MIAMI BEACH

Staff Report & Recommendation

SUBJECT: PB23-0625 1509 – 1515 Washington Avenue.

DATE: April 25, 2024

Delivery and Sanitation

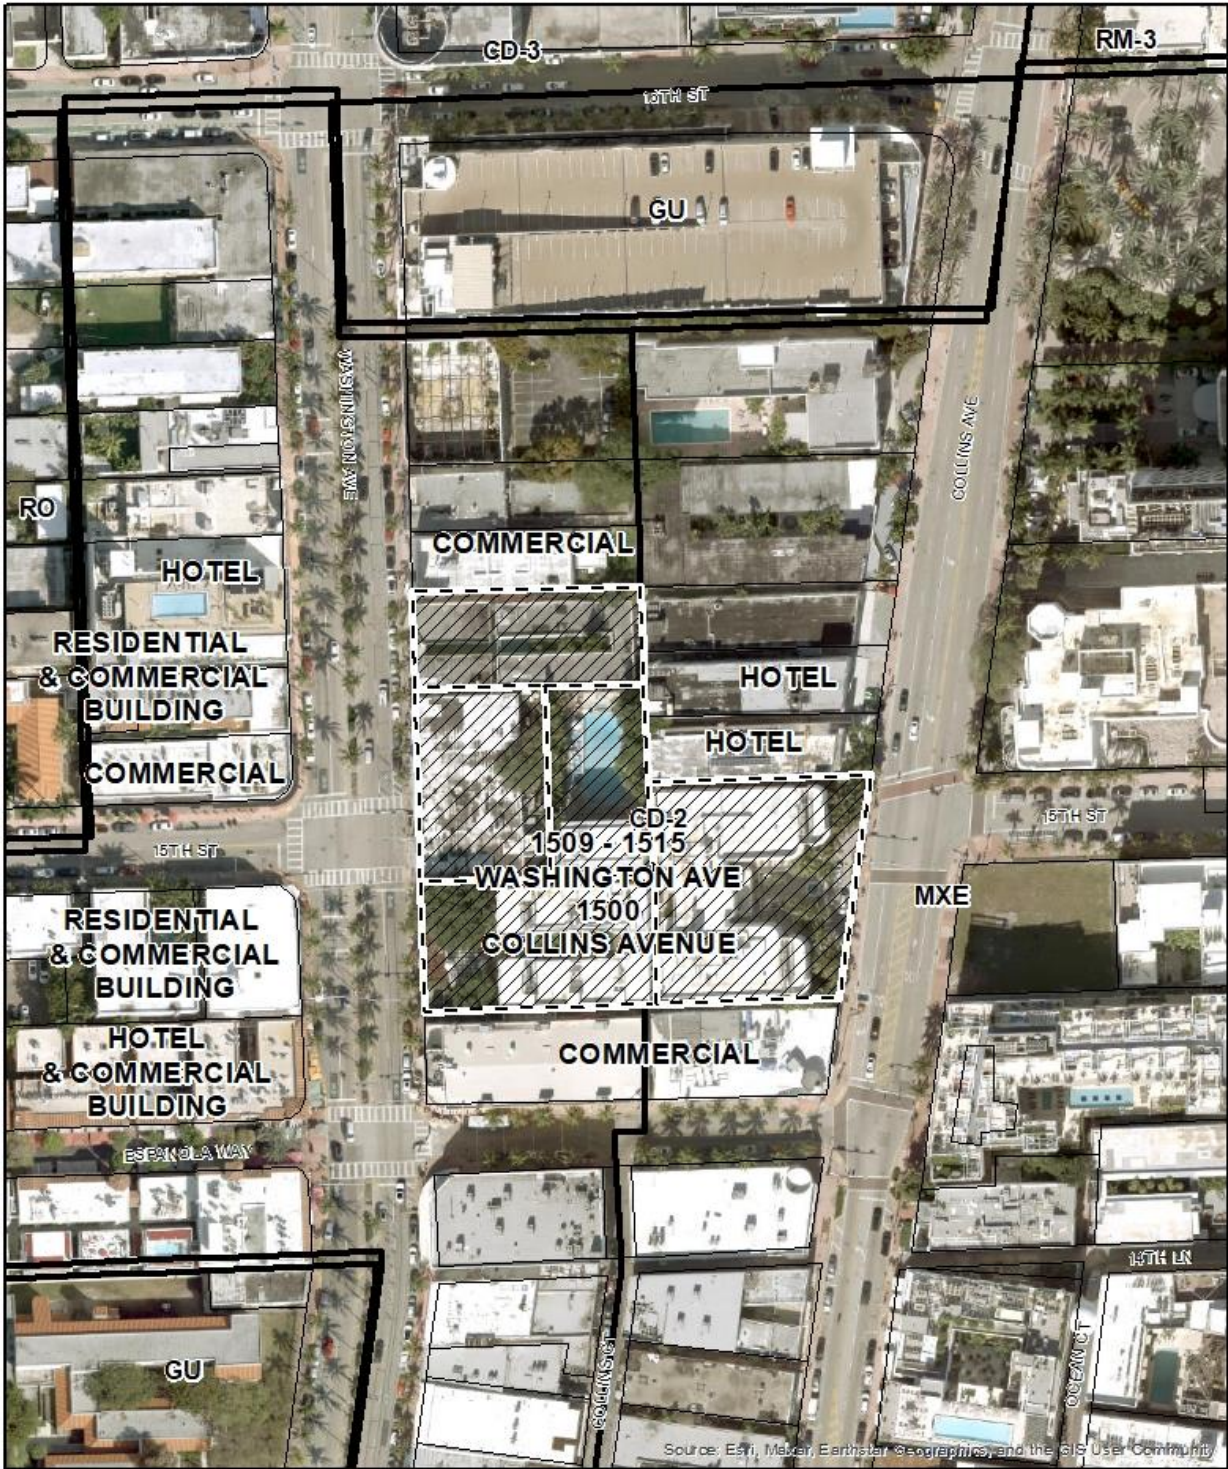
Pursuant to Section 5.2.6 of the LDR's, the project requires four (4) loading spaces onsite. The applicant is requesting a waiver from the Historic Preservation Board for this requirement in order to utilize the existing loading zone located north of the proposed project. Staff has recommended conditions to limit loading to off-peak daytime hours in order to minimize traffic disruptions and minimize noise impacts on surrounding properties.

Trash rooms are proposed at the south side of the property. Additionally, staff has recommended hours for trash pickups consistent with loading hours.
